UNITED STATES PATENT AND TRADEMARK OFFICE

09/892,790

Office Action Summary	Application No.	Applicant(s)	
	09/892,790	PARK ET AL.	
	Examiner	Art Unit	
	William J. Klimowicz	2627

DETAILED ACTION

FIG.4

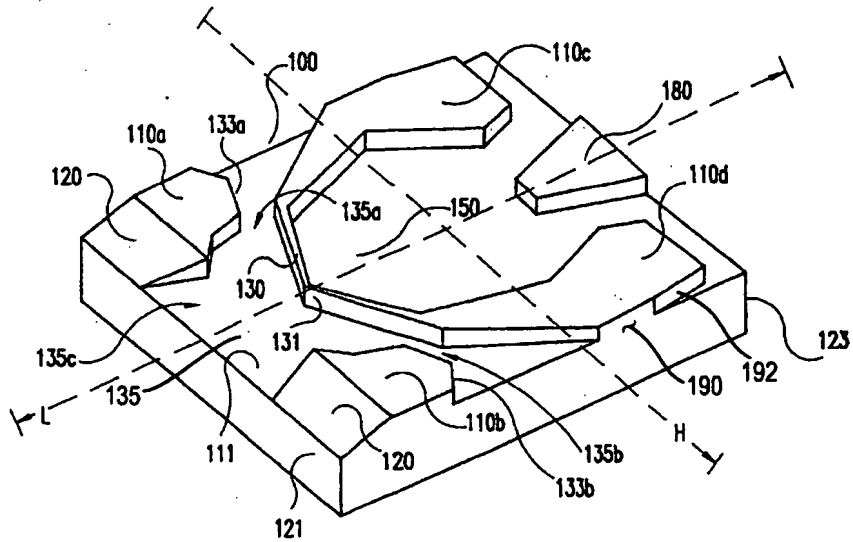
With regard to amended claim 21, the phrase “at least one of said not more than two separate air bearing platforms including a sidewall contiguous with one of said boundaries” is vague and ambiguous with respect to the Applicant’s disclosure and invention as described within the specification and drawings.

Emphasis added. The Applicant has now amended claim 21 to require that “at least one of said not more than two separate air bearing platforms including a ***sidewall contiguous with one of said boundaries***” (emphasis added) is misdescriptive of the invention as disclosed. None of the two separate air bearing platforms (e.g., 110c,

110d) are contiguous with the “boundaries” as previously defined within the claim. That is, the “boundaries” of the principal surface are defined by “said *front edge* [e.g., 121] and said *rear edge* [e.g., 123] *together . . . in a longitudinal direction of said slider body*,” See claim 21, lines 7-8. Emphasis added. That is, this is consistent with the longitudinal extent of the distance between the rear and the front edge of the slider along the longitudinal axis L as exemplified in Applicant’s Figure 4. Stated another way, the front edge (e.g., 121) defines one boundary; the rear edge (e.g., 123) defines another boundary. The front and rear edges (121, 123) together, define boundaries of the principal surface (e.g., 111) in a longitudinal direction (along L as seen, e.g., in FIG. 4) of the slider body (100). More specifically, none of the two separate air bearing platforms (e.g., 110c, 110d) are contiguous with either the front edge (121) or the rear edge (123) of the slider body, as depicted and/or described in the Applicant’s originally filed disclosure.

None of the two separate air bearing platforms (e.g., 110c, 110d) extend from an edge of one of the boundaries (at 121 and/or 123) as depicted and/or described in the Applicant’s originally filed disclosure.

Again, as is factually evident, none of the two separate air bearing platforms (e.g., 110c, 110d) extend from an edge of one of the boundaries (at 121 and/or 123) as depicted and/or described in the Applicant’s originally filed disclosure.

Emphasis added. The Applicant has now amended claim 21 to require that “at least one of said not more than two separate air bearing platforms including a ***sidewall contiguous with one of said boundaries***” (emphasis added). As originally disclosed, however, none of the two separate air bearing platforms (e.g., 110c, 110d) are contiguous with the “boundaries” as previously defined within the claim. That is, the “boundaries” of the principal surface are defined by “said **front edge** [e.g., 121] and said **rear edge** [e.g., 123] **together . . . in a longitudinal direction of said slider body**.” See claim 21, lines 7-8. Emphasis added. That is, the language is consistent with the longitudinal extent of the distance between the rear and the front edge of the slider along the longitudinal axis L as exemplified in Applicant’s Figure 4. Stated another way, the front edge (e.g., 121) defines one boundary; the rear edge (e.g., 123) defines another boundary. The front and rear edges (121, 123) together, define boundaries of the principal surface (e.g., 111) in a longitudinal direction (along L as seen, e.g., in FIG. 4) of said slider body (100). More specifically, the invention as originally filed, fails to disclose any of the two separate air bearing platforms (e.g., 110c, 110d) as being contiguous with either the front edge (121) or the rear edge (123) of the slider body, as depicted and/or described in the Applicant’s originally filed disclosure.

None of the two separate air-bearing platforms (e.g., 110c, 110d) extend from an edge of one of the boundaries (at 121 and/or 123) as depicted and/or described in the Applicant’s originally filed disclosure.

Again, as is factually evident, none of the two separate air-bearing platforms (e.g., 110c, 110d) extend from an edge of one of the boundaries (at 121 and/or 123) as depicted and/or described in the Applicant's originally filed disclosure.

Note furthermore that even Applicant’s own description of the invention, makes it abundantly clear, that the side edge of the slider body is not necessarily parallel or contiguous with a sidewall of the slider body. For instance, as Applicant recites in the amendment to the specification (e.g., see page 2 of Applicant’s amendment filed August 22, 2007):

The U-shaped air-bearing platform circumscribes a majority of negative pressure cavity 150 that is formed on principal surface 111. At least one of the rear ABS platforms 110c, 110d includes a sidewall 190 that is contiguous with *side edge 192 of slider body 100* extending between lead edge 121 and rear 123 . . . [Emphasis added - see Applicant’s amended FIG. 4, also filed on August 22, 2007.]
